Clyde Waterfront Renfrew Riverside & Glasgow Airport Investment Area

Scoping Update

CWRR & GAIA City Deals: Scoping Report Update Note
 Doc Number: 117086-SWECO-EGN-00-SP-EN-00001

Figure 2.1 – GAIA

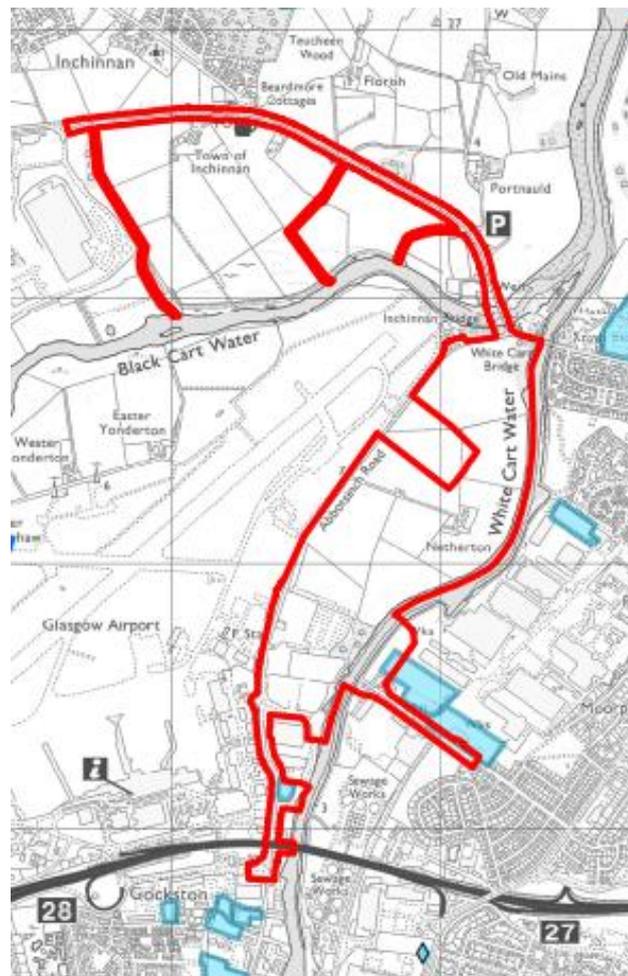
- Gateway link, at the southern end of the GAIA scheme has been removed from the project;
- Three outfalls have been included to supply drainage for the cycleway at Inchinnan; and
- The Wright Street bridge design has progressed and there are now two piers which would be located in the White Cart River.

An updated redline boundary plan of the proposed GAIA project is provided in Figure 2.1.

Figure 2.2 – GAIA Gateway (now removed)

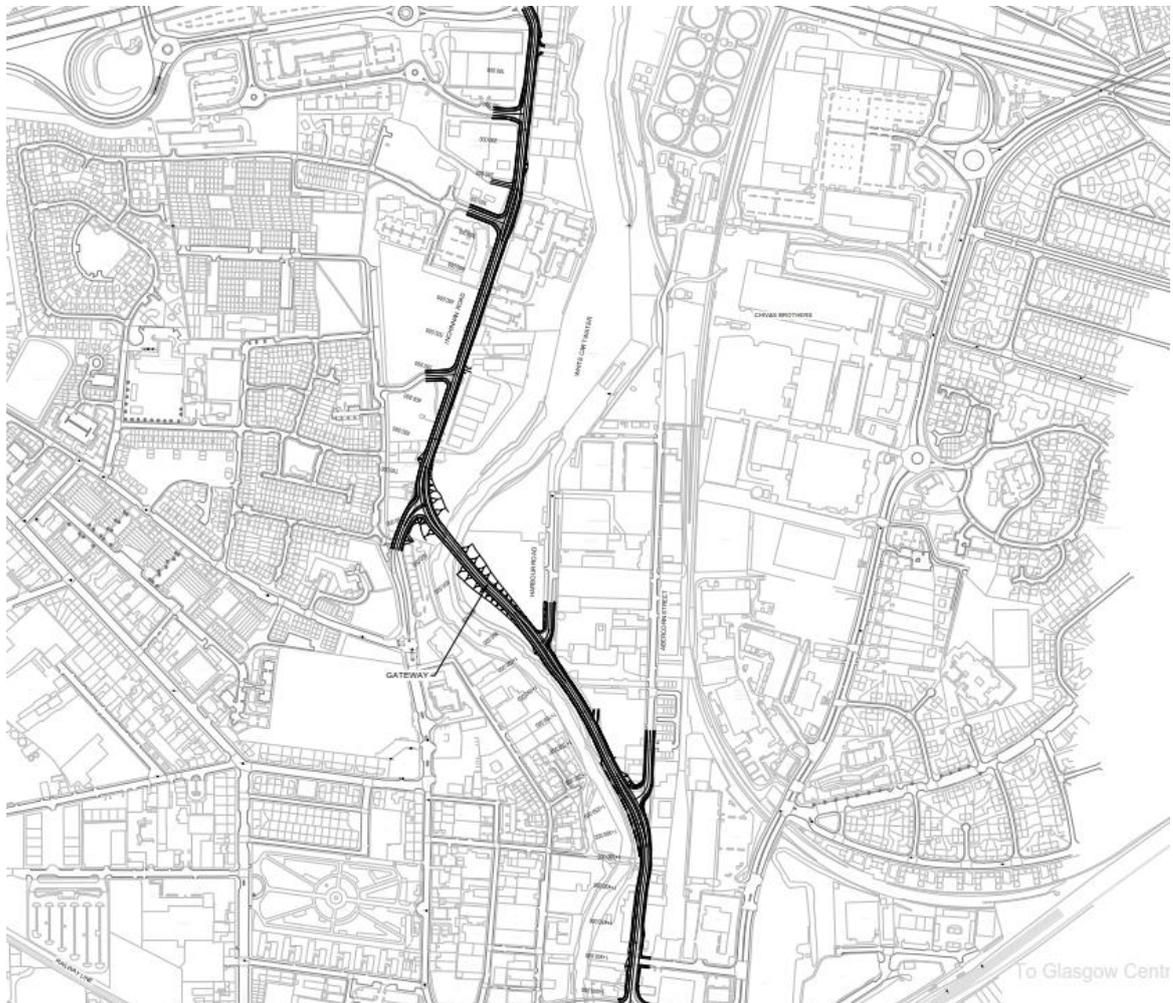
Due to funding restrictions, the previous Gateway element of the GAIA project (including the proposed road bridge crossing of the White Cart Water in the Paisley Harbour area and connecting roads) has been removed completely from the project. Figure 2.2 shows the removed Gateway element.

With regards to changes to the proposed environmental assessments, any reference to Gateway will be removed in the EIA and is not being assessed in the individual assessments or as part of the cumulative assessment.

Traffic flows predicted from the traffic model associated with the former Gateway element of the project have also been removed and will not be considered as part of the traffic, air quality or noise assessments. Overall, no changes are proposed to the assessment methodology of traffic related environmental impacts set out in the GAIA Scoping Report.

Figure 2.3 – Proposed location of GAIA Drainage (shown in green circles)

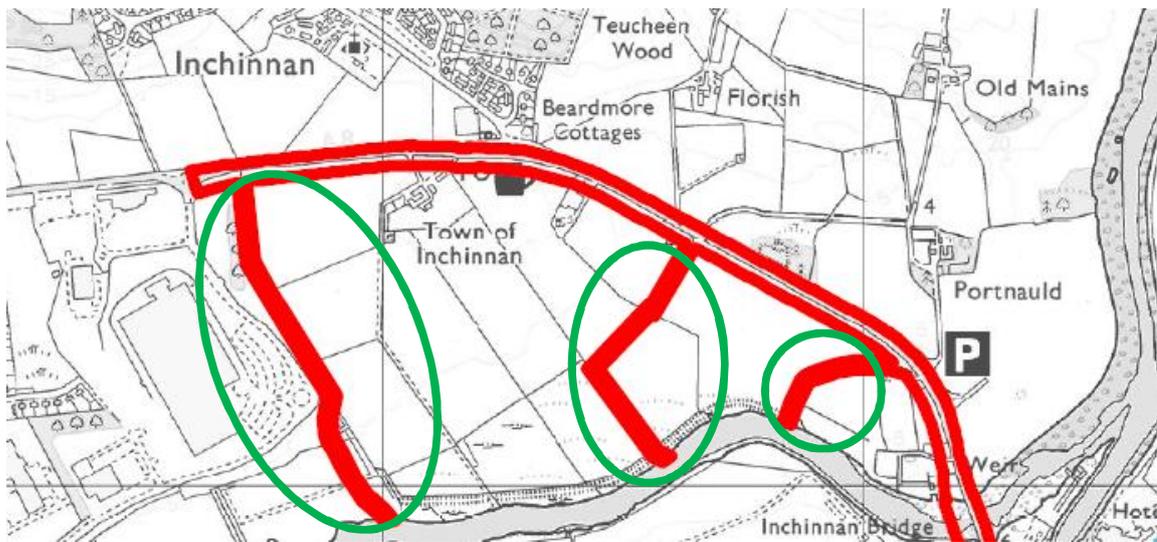
Along the proposed Inchinnan Cycleway, the redline boundary has been revised to include for possible connections into three existing outfalls to provide drainage for surface water run-off from the new cycleway. Figure 2.3 indicates the locations of these channels which would run from the proposed Inchinnan Cycleway and discharge to the Black Cart Water. The westernmost of these seeks to connect into the existing network at the eastern end of the Inchinnan Business Park. The remaining two drainage outfalls are located on existing water courses/ drainage channels which lead to, and outfall at, the Black Cart Water.

The proposed cycleway is remote from the carriageway and is required to cross two existing channels; culverts are proposed at the head of these channels which will require sizing to accommodate the existing flows and any runoff intercepted by the cycleway drainage. Any requirement for channel realignment for culvert connection is to be confirmed.

Based upon the information provided above regarding the drainage proposals, it is predicted that the drainage solutions required for the cycleway would not result in any significant environmental effects as long as best practice was adopted during construction.

Figure 2.4 – Wright Street Bridge

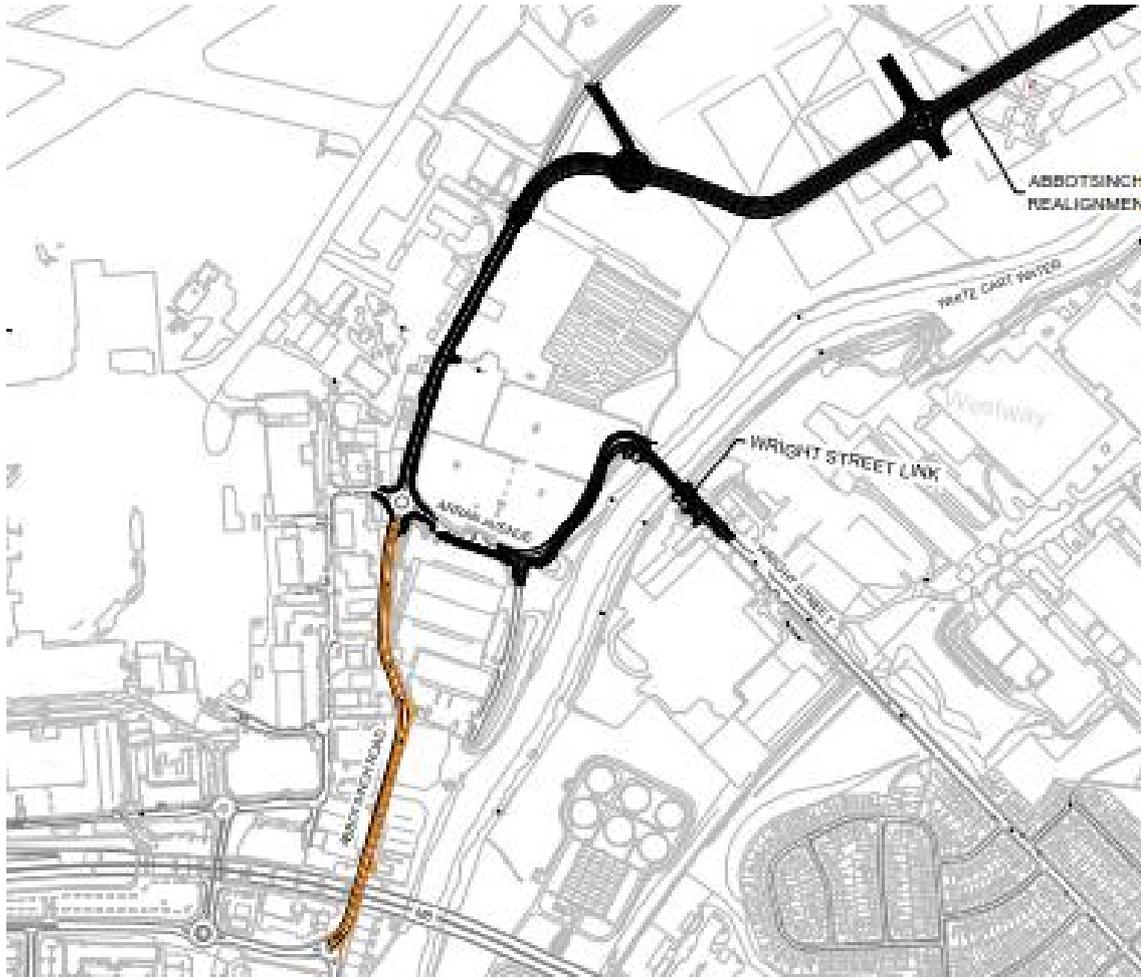
The design of the Wright Street Bridge has been progressed and will now be a 3 span structure, with two proposed piers in the White Cart. The bridge will be approximately 13m wide and with an overall length of approximately 70m and will cross the river at the point shown in Figure 2.4 below. It is anticipated that the piers will be supported on reinforced concrete piles. It is estimated that it would take approximately six months to construct this bridge, with in river works taking three months. An indicative cross section for the bridge is shown in Figure 2.5.

The proposed crossing is not materially different in design from that previously assumed at scoping with the exception of the requirement for piers to be located in the watercourse. During the Wright Street bridge design process, a variety of bridge types (multispan and single span) were investigated. The preferred option was found to be the bridge with the two in river piers. This option provided a suitable tie in with Wright Street, ensured that road levels could be maintained for access to existing businesses and also provided significant cost savings when compared with the single span options.

Figure 2.6 – CWRR Proposals

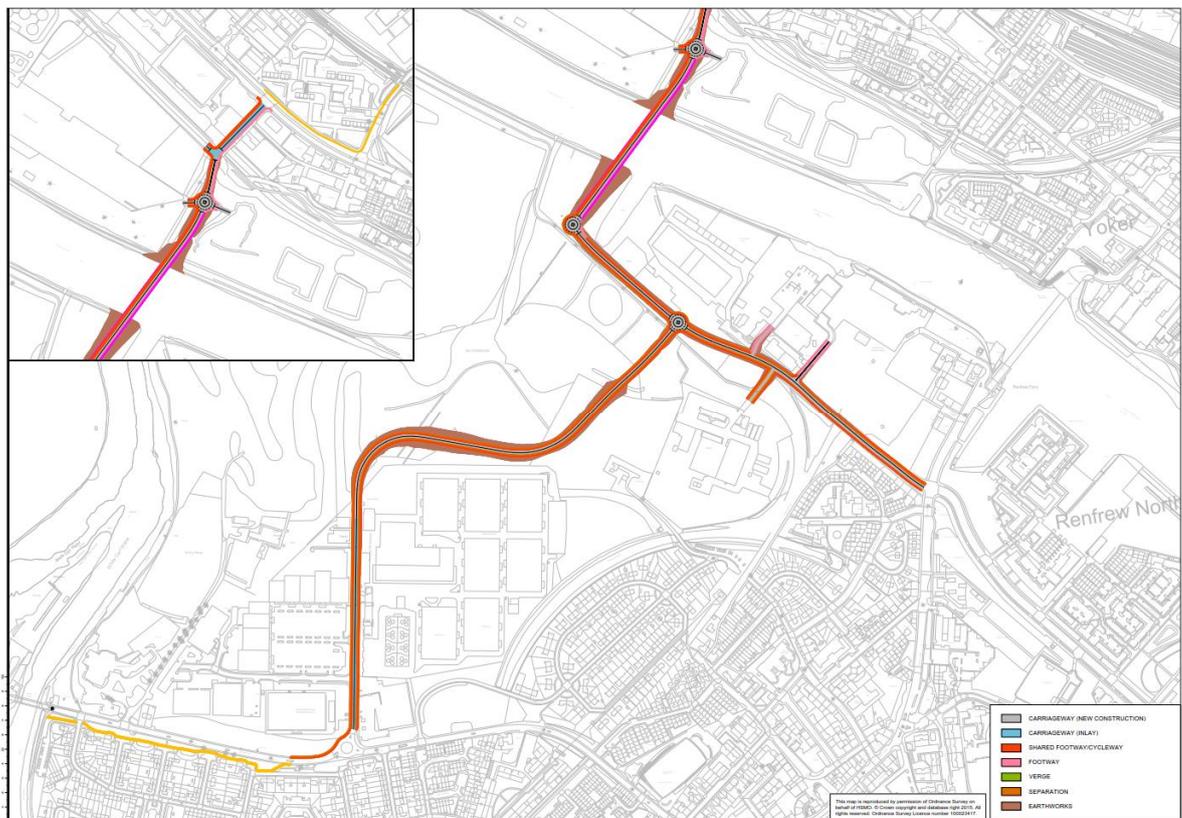
- Clyde crossing;
- Yoker Burn culvert realignment;
- Cycleway from Dock Street to Yoker Train Station via Glasgow Road;
- Layby berthing structure; and
- Additional drainage outfalls.

A revised plan showing the overall infrastructure proposals for the CWRR project is presented in Figure 2.6.

Figure 2.8 – Layby Berthing Location

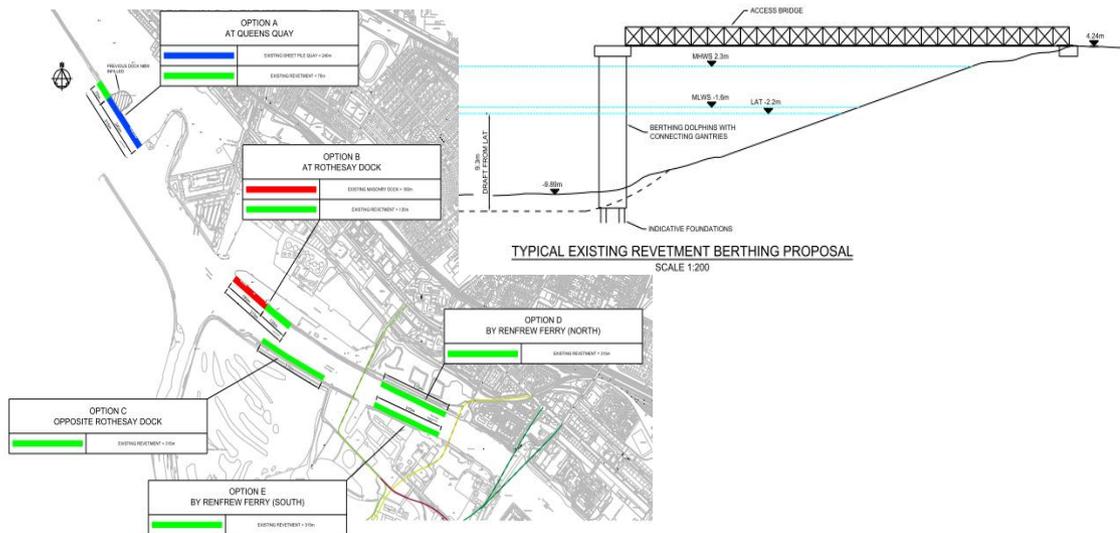
The development proposals for CWRR therefore now include for a layby berthing structure. This is anticipated to take the form of up to eight piled concrete 'dolphins'¹ that will be situated directly adjacent to the navigational channel. There will be continuous fendering out of the water connecting the dolphins and associated connecting walkways and gantries to provide access to moored vessels from the adjacent Rothesay Dock. The proposed location (option B – Rothesay Dock) of the layby berthing is provided below in Figure 2.8.

Figure 2.9 – CWRR Additional Outfalls (*locations shown in green circle*)

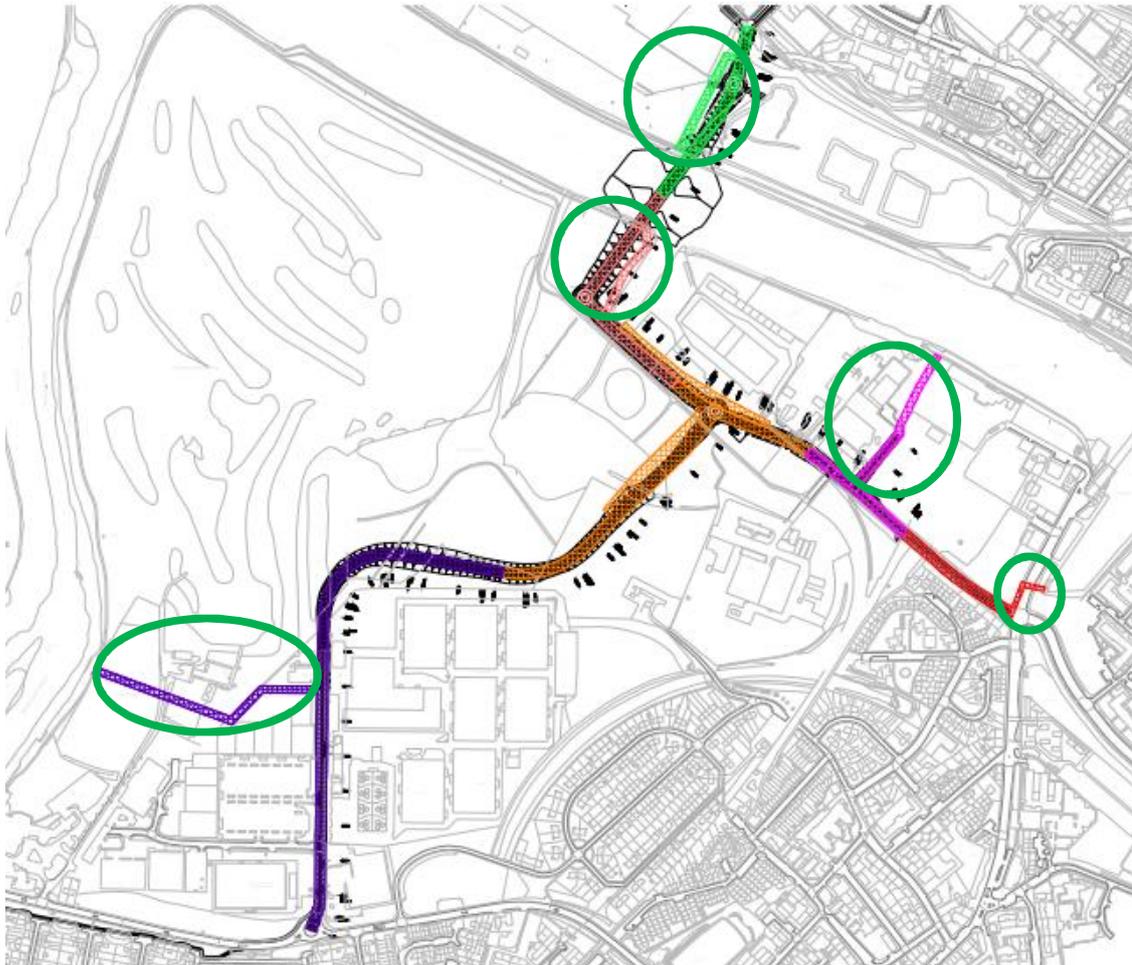
The Renfrew Northern Development Road drainage proposals are based upon an outfall solution that will provide the required capacity for discharge of surface water run-off from the new road. Five additional outfalls will be required as shown in Figure 2.9 below. These outfalls will be constructed using a standard pipe, trench and headwall construction methodology

The drainage proposals will provide an appropriate level of treatment to surface water run-off, in accordance with accepted pollution control measures to ensure that there is no polluted water travelling directly into the receiving watercourses (the lower Cart Water and the River Clyde).
